TRANSMITTAL OF INFORMATION TO COMPLETE DEFENSE NUCLEAR FACILITIES SAFETY BOARD (DNFSB) RECOMMENDATION 93-5 MILESTONE 5.4.3.5c

COMPLETION OF DEFENSE NUCLEAR FACILITIES SAFETY BOARD RECOMMENDATION 93-5 IMPLEMENTATION PLAN, REVISION 1, COMMITMENT 5.4.3.5c, *LETTER REPORTING APPROVAL OF SAFETY ASSESSMENT FOR ROTARY MODE CORE SAMPLING IN FLAMMABLE GAS TANKS AND DOCUMENTING INCORPORATION INTO THE INTERIM SAFETY BASIS*

- (2) WHC-SD-WM-SAD-035, "A Safety Assessment of Rotary Mode Core Sampling in Flammable Gas Single Shell Tanks: Hanford Site, Richland, Washington," dated August 8, 1996.

Fig. 2-1. Typical A-Farm SST cross section.

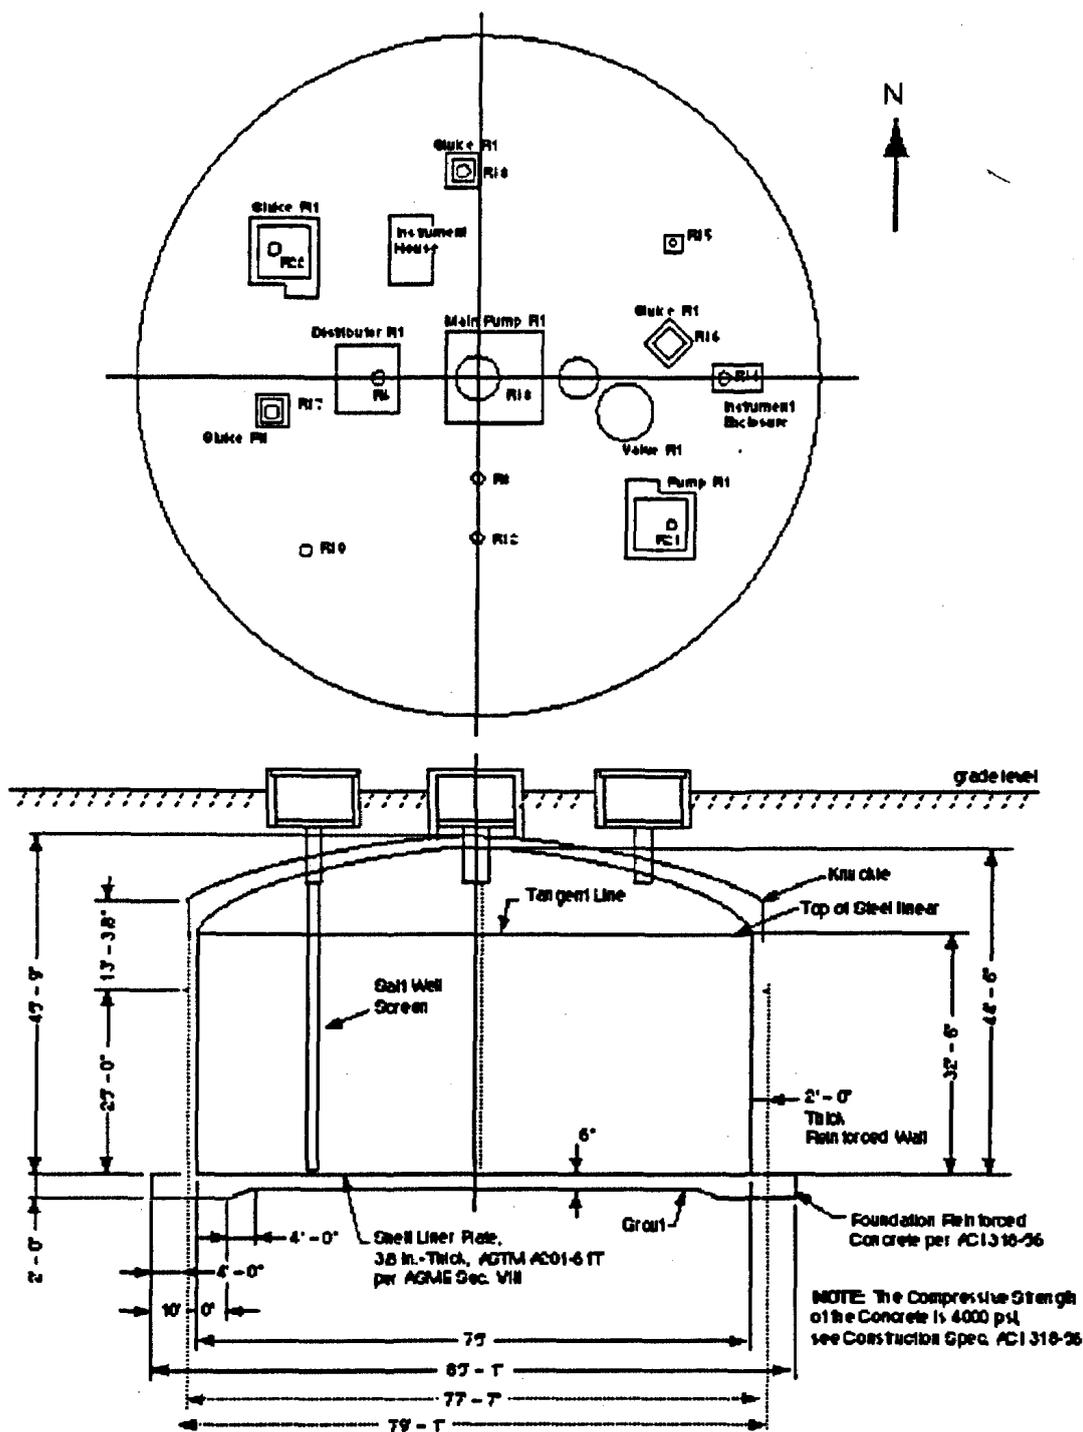
<p>BEI 12 2-9 2.3 Fig. 2.1 E</p> <p><i>See Tank about other Tanks.</i></p>	<p>Please insert a drawing that an engineer could find acceptable. This tank is out of scale, lop-sided, and probably inaccurate.</p> <p><i>OK</i></p> <p><i>HOWEVER INFORMATION PROVIDED BY THE NEW FIGURES IS DIFFERENT FROM WHAT WAS ON OLD FIGURES -</i></p>	<p>Note Figure 2-1 is a schematic. A schematic is a broad, diagrammatic presentation. A detailed civil engineering drawing was not intended.</p> <p>However, an improved schematic was added with representative dimensions.</p> <p>The engineering drawings are available for the reviewers.</p>	
<p>din 4 2-8 2.3 last 0</p>	<p>This section describes that the HEPA filters are protected by a small loop seal to protect against a plugged filter. This is also potential for an unmitigated release of radioactive and hazardous material if the loop seal is unintentionally voided of the seal material or needed to relieve the pressure from a plugged filter. This potential accident scenario should be included in the safety analysis of system operation.</p>	<p><i>OK</i></p> <p>The loop filter seal is on the tank breather inlet HEPA. The presence of the RMCS does not increase the probability of loop seal failure and reduces the probability of unmitigated release (due to the presence of the exhaustor) in the event of a loop seal failure.</p>
